Access Compliance Report

Public Rights-of-Way

Intersection ID: 2600	Main Street: CAMBELLTON_DR	Cross Street: FAIRMEADOWS_DR	Location: S
ADA ID: 09466E518DB8	Ramp Type: PerpDiag	Initial Pass/Fail: Fail	Overall Compliance: No
		Severity Score: 10

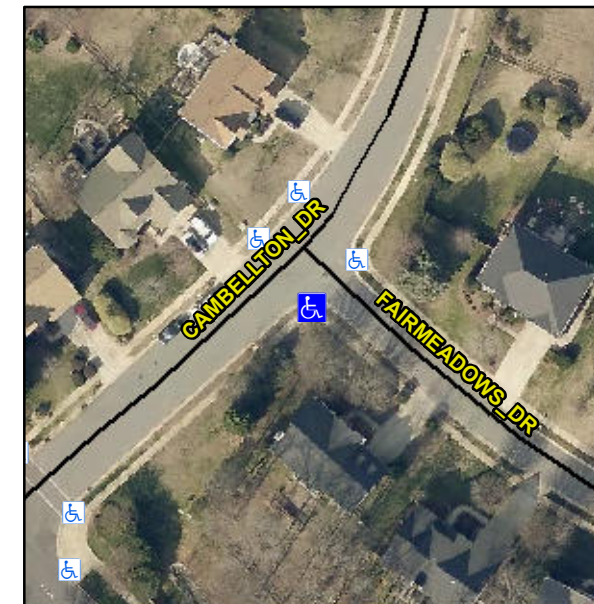
Not Found, R304.5.1, R304.5.3

Compliance	Description	Data	Compliance	Description	Data
N/A	Ramp Length (in)	36.0	Yes	Ramp Slope (%)	7.0
No	Ramp Width (in)	47.0	No	Ramp XSlope (%)	3.9
N/A	Flare Type LT	N/A	N/A	Flare Type RT	N/A
N/A	Flare Slope LT (%)	N/A	N/A	Flare Slope RT (%)	N/A
N/A	Flare Traversable LT?	N/A	N/A	Flare Traversable RT?	N/A
N/A	Landing Length (in)	N/A	N/A	DWS Provided?	N/A
N/A	Landing Width (in)	N/A	N/A	DWS Contrast?	N/A
N/A	Landing Slope (%)	N/A	N/A	DWS Length (in)	N/A
N/A	Landing X Slope (%)	N/A	N/A	DWS Full Width?	N/A
N/A	Landing Curb? (Y/N)	N/A	N/A	DWS Offset (in)	N/A
N/A	Shared Landing?	N/A			
N/A	Gutter Ponding?	N/A	N/A	Gutter Slope (%)	N/A
N/A	Gutter Lip Ht (in)	N/A	N/A	Gutter X Slope (%)	N/A
N/A	Painted X Walk1?	No	N/A	Painted X Walk2?	No
	X Walk 1 Direction	To NE		X Walk 2 Direction	To NW
N/A	X Walk 1 Width (in)	N/A	N/A	X Walk 2 Width (in)	N/A
	X Walk 1 Slope (%)	5.1		X Walk 2 Slope (%)	2.6
	X Walk 1 X Slope (%)	2.3		X Walk 2 X Slope (%)	6.2

Remove & Replace Curb Ramp With Two New Directional Ramps or Equivalent.
